South Texas Project Electric Generating Station P.O. Box 289 Wadsworth, Texas 77483

August 19, 2010  
U7-C-STP-NRC-100193

South Texas Project  
Units 3 and 4  
Docket Nos. 52-012 and 52-013  
Revised Response to Request for Additional Information

**RAI 03.08.04-18, Revision 1, Supplement 1****QUESTION:****Follow-up to Question 03.08.04-2 (RAI 2964)**

SECTION A-A

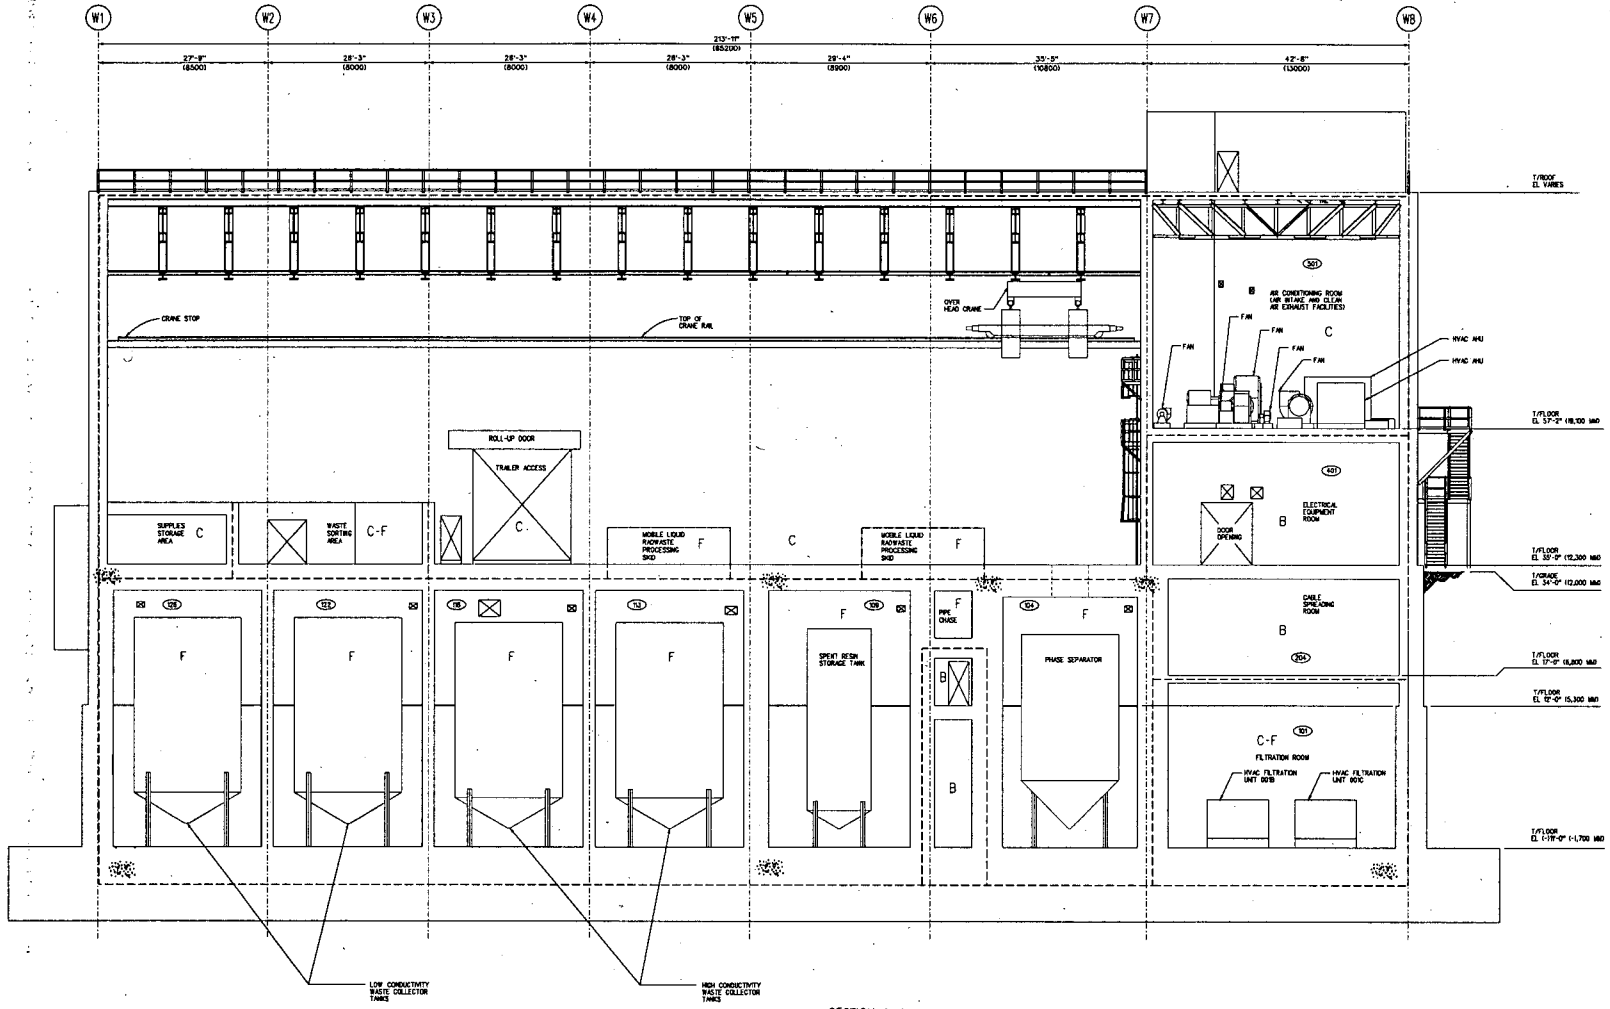
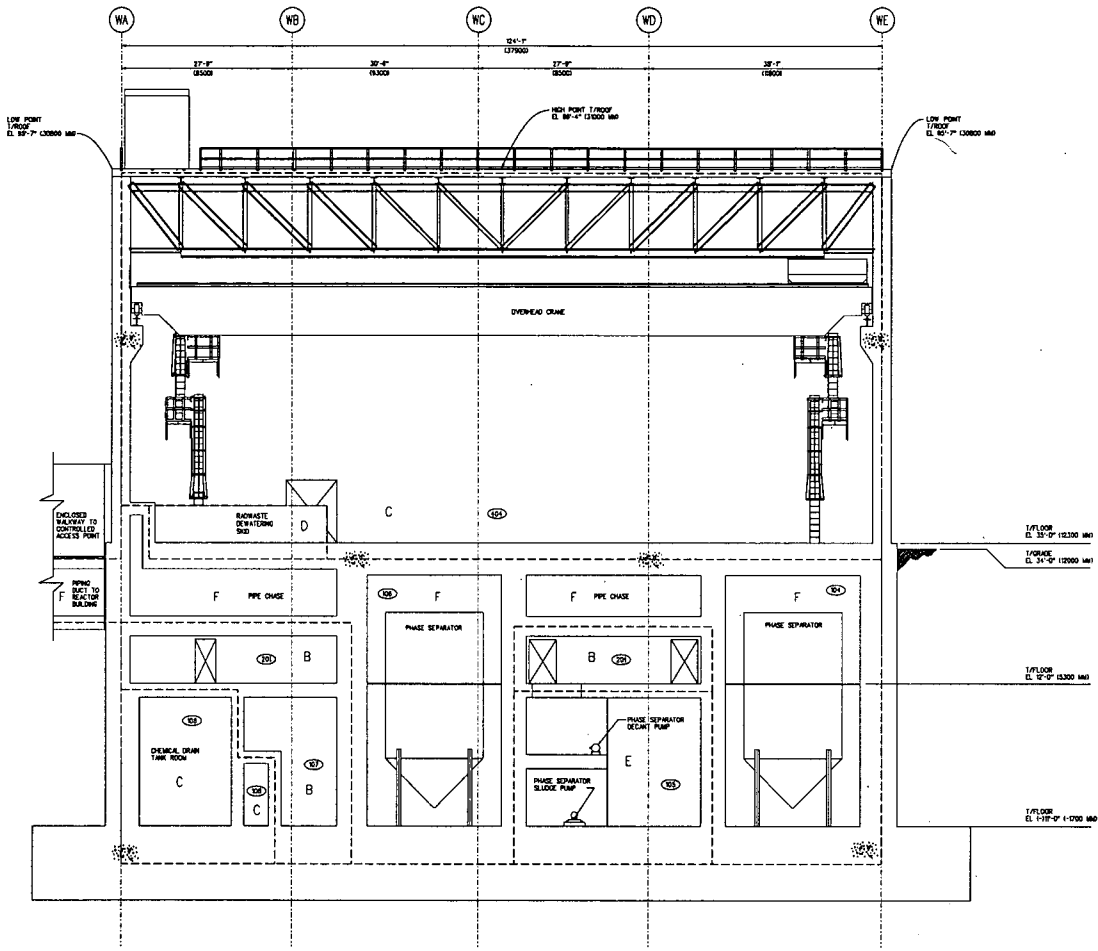
#### **Radiation Zone Maps (Figures 12.3-37 through 12.3-41)**

The changes in the arrangement shown on the RWB GAs do not result in any changes to the radiation zone designations for the various areas (equipment rooms, pipe chases, hallways, etc) in the RWB. The radiation sources in the individual rooms remain the same (i.e., the room and the source in it are moved), and the shielding is adjusted as necessary to ensure the radiation levels in protected areas correspond to the established radiation zone (the shield wall thickness changes are associated with situations where the area outside of the room has a different radiation zone). The changes in the shielding wall thicknesses are described in the markup of FSAR Table 12.2-5c (see below).

FIGURE 12.3-66 RADWASTE BUILDING, AREA RADIATION MONITORS AT ELEVATION 5300 MM

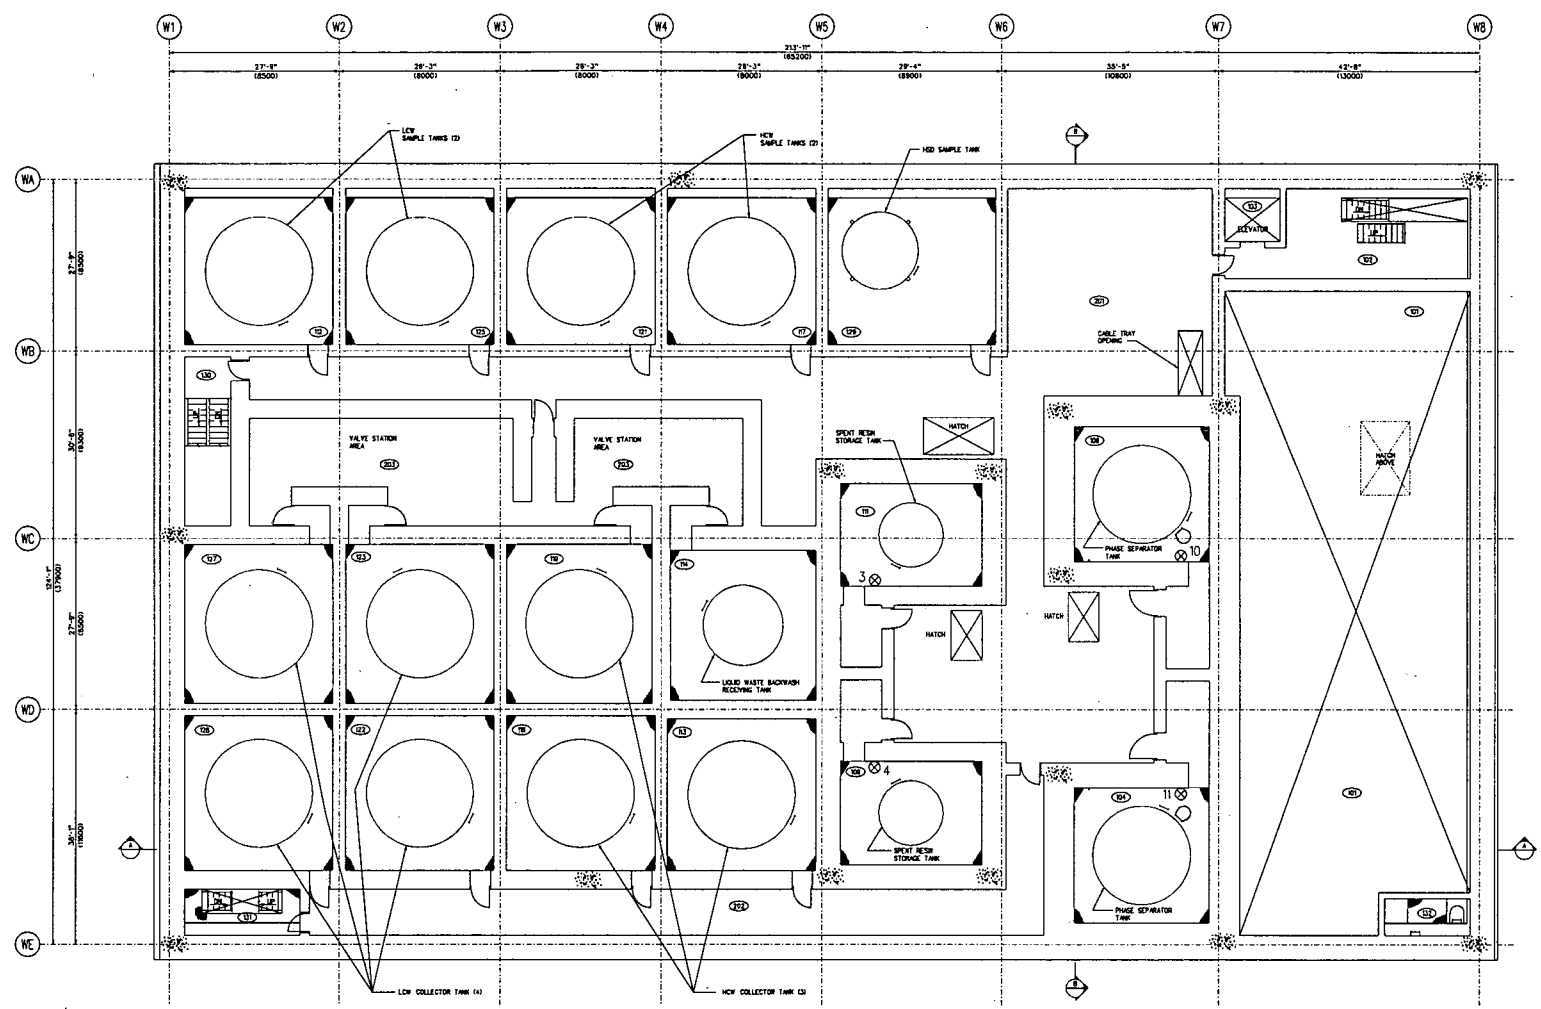
#### **Figure 12.3-66**

- The Electrical Equipment Room radiation monitor (No. 1) is removed from this figure, and is now shown on Figure 12.3-67 because the room was moved to that elevation. It serves the same function.
- The phase separator tank room monitors (No. 10 and 11) were moved from the west end of the RWB to near the east end because the phase separator tank rooms were moved. The radiation monitors are still located inside the phase separator tank rooms. They are relocated with the tanks and serve the same function,
- The spent resin tank room monitors (No. 3 and 4) were moved west one column row because the spent resin tank rooms were moved. The radiation monitors are still located inside the spent resin tank rooms. They are relocated with the tanks and serve the same function.

FIGURE 12.3-67 RADWASTE BUILDING, AREA RADIATION MONITORS AT ELEVATION 12300 MM

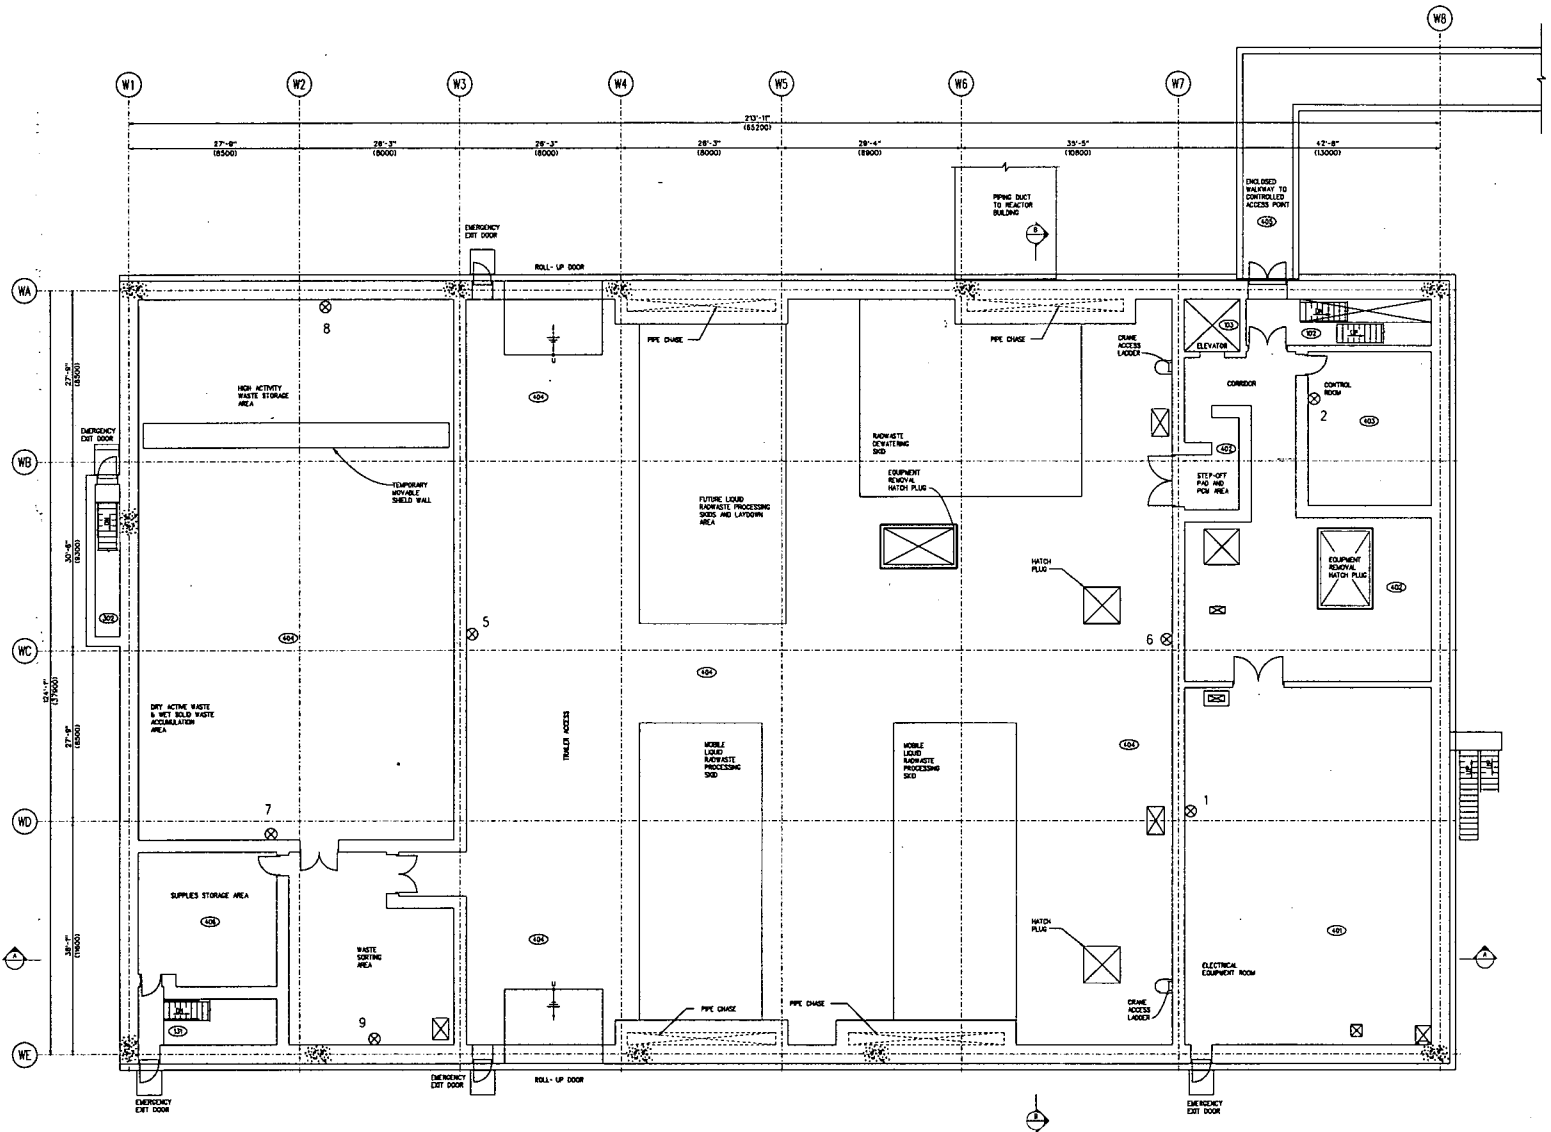
## Figure 12.3-67

- The Electrical Equipment Room radiation monitor (No. 1) is added to this figure because the room was moved to this elevation. It was previously shown on Figure 12.3-66. This location is comparable to previous location and the function is the same.
